ITEM NO: 06

Application No.
21/00317/PAR

**Parkfield House Cambridge Road Crowthorne
Berkshire**

Prior approval application for additional storey to provide residential accommodation comprising of 2 No. 1 bed flats and 3 No. 2 bed flats.

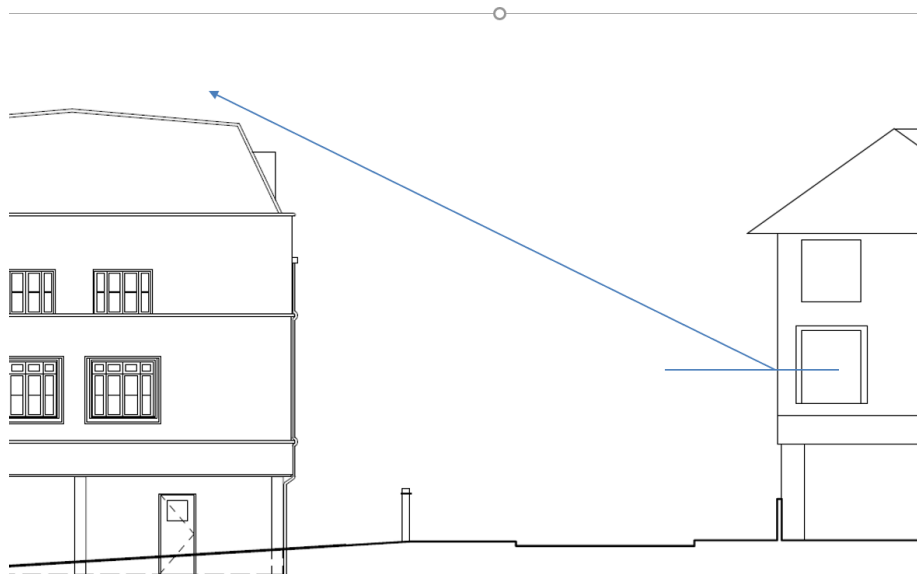
9.30 This dwelling is located on slightly higher ground, approximately 20m from the built form of the proposal, with the car park separating Parkfield House and the garden and property of 1 Thornton Mews. The side elevation of 1 Thornton Mews faces the application site. 1 Thornton Mews has a single storey rear projection with patio doors which face the application site. Window to window there would be a separation distance of 24.5m between the patio doors and the windows to the proposed flats and between 20 and 21.5m to the boundary and garden.

9.31 The Design SPD provides guidance on what separation distances should be achieved to ensure reasonable levels of privacy, with 22m between facing windows of two storey properties being acceptable, but 30m should be sought for windows above first floor level.

9.32 There are already windows at second floor at a distance of 22.8m from the ground floor window in Thornton Mews. The proposed third floor window would be set back from the elevation by 1.5m increasing the separation distance to 24.5m at this height. It is considered that given the existing relationship, and the additional set back there would not be a significant increase in overlooking to result in a refusal of permission.

9.33 A separation distance of 20m to the garden is considered acceptable.

9.34 In addition a loss of light assessment has been undertaken in accordance with the BRE Site layout and planning for daylight and Sunlight – a guide to good practice. This demonstrates that there would be no significant loss of light to the habitable room served by the patio doors.
